ENGINEERING CHANGE NOTICE NO.

04274

DWG NO. 646.3500

DWG TITLE: STRUT

SHEET 1, ZONE A1 IS:

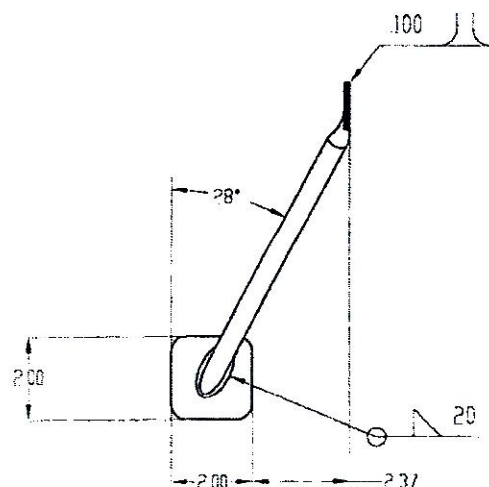
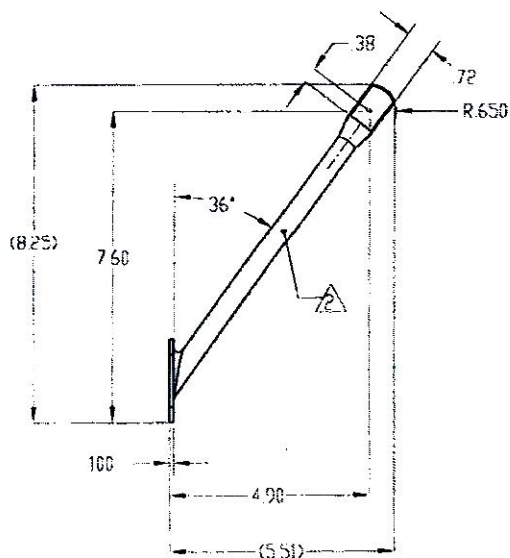
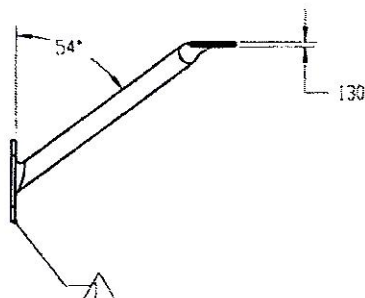
REASON: REVISED DELTA NOTE 1 & 2.

- 1 MATERIAL: AISI 304/ 316 SS SHEET .062 THK
(REF DART SPEC. M304S16GA)
- 2 MATERIAL: AISI 304/316 SS 0.500 OD X 0.049 WALL
(REF DART SPEC. M304TR0.500W0.049)
ENSURE SEAMLESS TUBE IS USED
- 3 FINISH: HARD ANODIZE IAW MIL-A-8625 TYPE III, CLASS 2
COLOR BLACK;
CARDINAL 4860-50 PRETREATMENT PRIMER
PRIME IAW MIL-P-23377J TYPE I CLASS N
4. DEBURR AND BREAK ALL SHARP EDGES
5. WELDS IAW MIL-STD-2219.
TIG WELD WITH FILLER ROD

SHEET 2, IS:

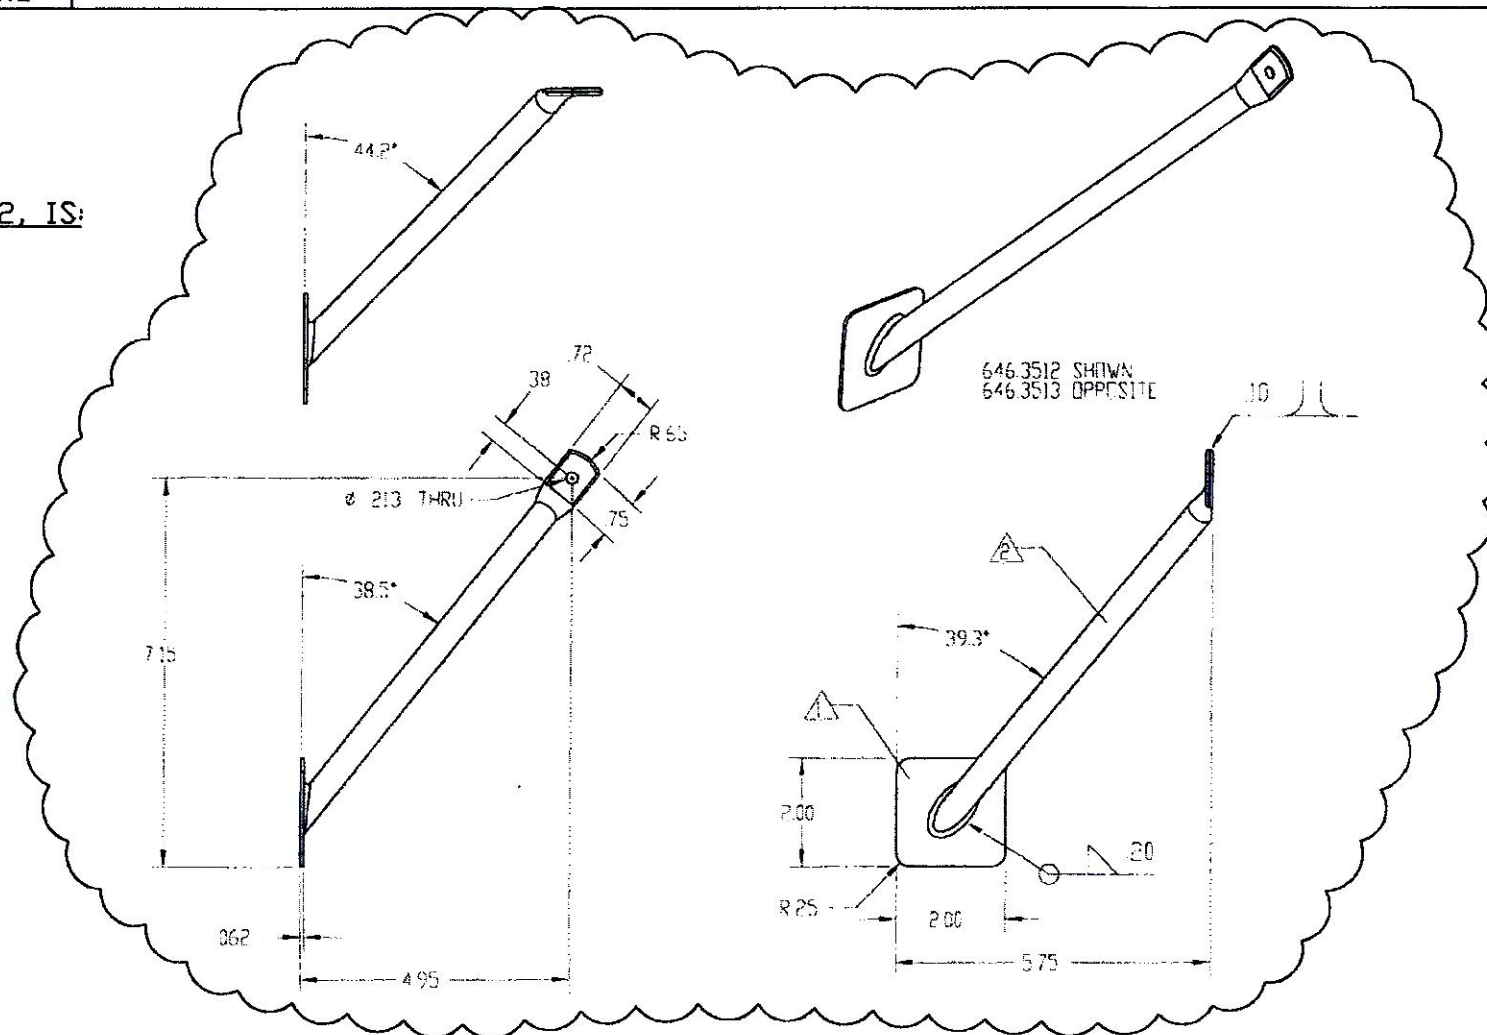
REASON: REVISED ANGLE OF 646.3512 & 646.3513 FOR BETTER FITMENT
